17DevPlan1048

3122 Dixie Highway

Louisville Metro Board of Zoning Adjustment Public Hearing

Steve Hendrix, Planning & Design Supervisor
October 2, 2017

PLAN

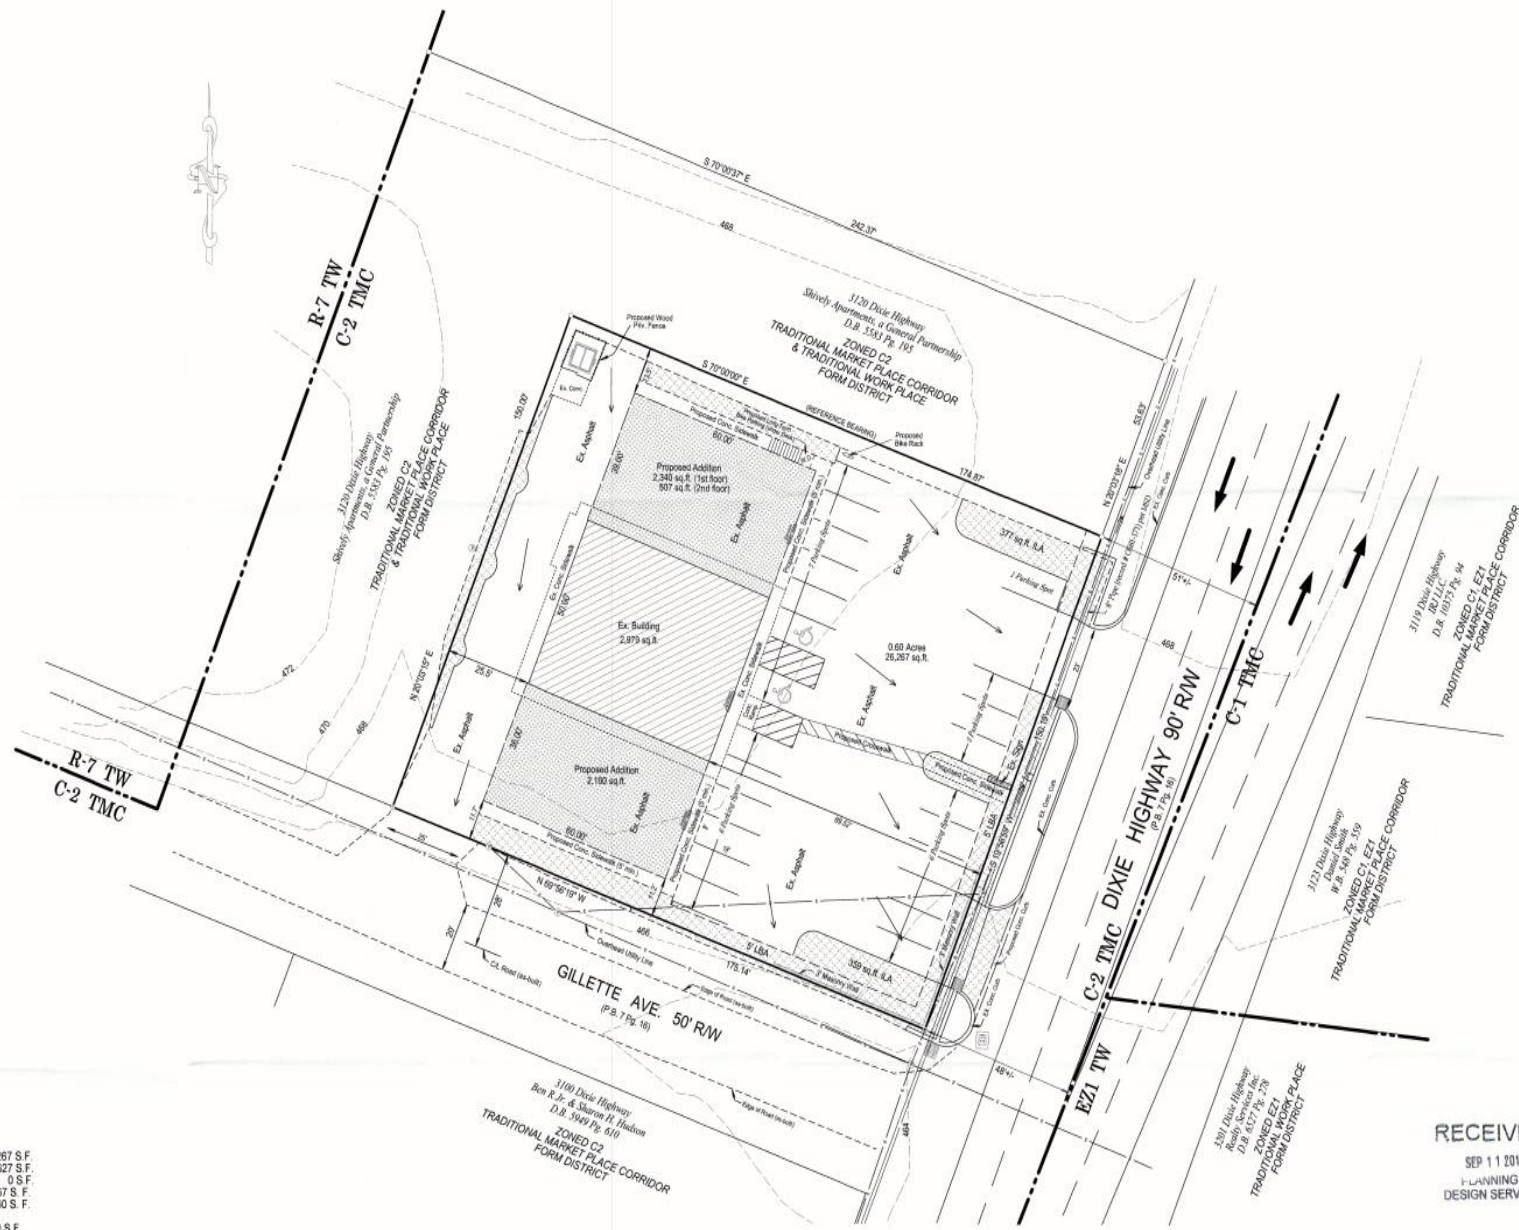
1. Variance to allow the proposed laundromat to be 6 feet, 2 inches beyond the Gillette Avenue setback.
2. Variance to allow the existing building and proposals to be 84 feet beyond the Dixie Highway setback.
3. Waiver to allow parking to be permitted in the front of buildings.
4. Waiver to provide 50 foot long, 3 foot tall masonry walls along Gillette Avenue and Dixie Highway from the corner.
5. Waiver not to provide a sidewalk along the northern side of Gillette Avenue.

1. Sight distance concerns are not affected.
2. Character of the vicinity remains .
3. Will not cause a hazard or nuisance.
4. Allows for modification of the existing convenience store.

1. Sight distance concerns are not affected.
2. Essential character remains the same, convenience store has been at this location for approximately 10 years, used car lot before.
3. Traffic safety will improve on Dixie Highway
4. Majority of commercial uses along Dixie have similar setbacks.

1. Will not adversely affect adjacent property owners.
2. Will not violate specific guidelines (will be in character with the surrounding areas).
3. Parking will remain basically the same, except elimination of parking on the Gillette Avenue side.
4. Existing location of the convenience store and modifications.

1. Will not adversely affect adjacent property owners.
(Most of apartment units will be facing the side of the laundromat, parking will be more than 100 feet from apartment house that is across Dixie Highway, C-1 zoning.

2. The wall establishes the corner, encloses most of the parking and at the same time balances safety and pedestrian considerations.

1. Extensive pavement exists on the south side of Gillette Avenue that provides ample room for pedestrians, bicyclists and transit users.
2. Unnecessary hardship for the applicant if required since there is existing pavement .
3. More concrete.

The variance and waiver requests all appear to be adequately justified and meet the standard of review.
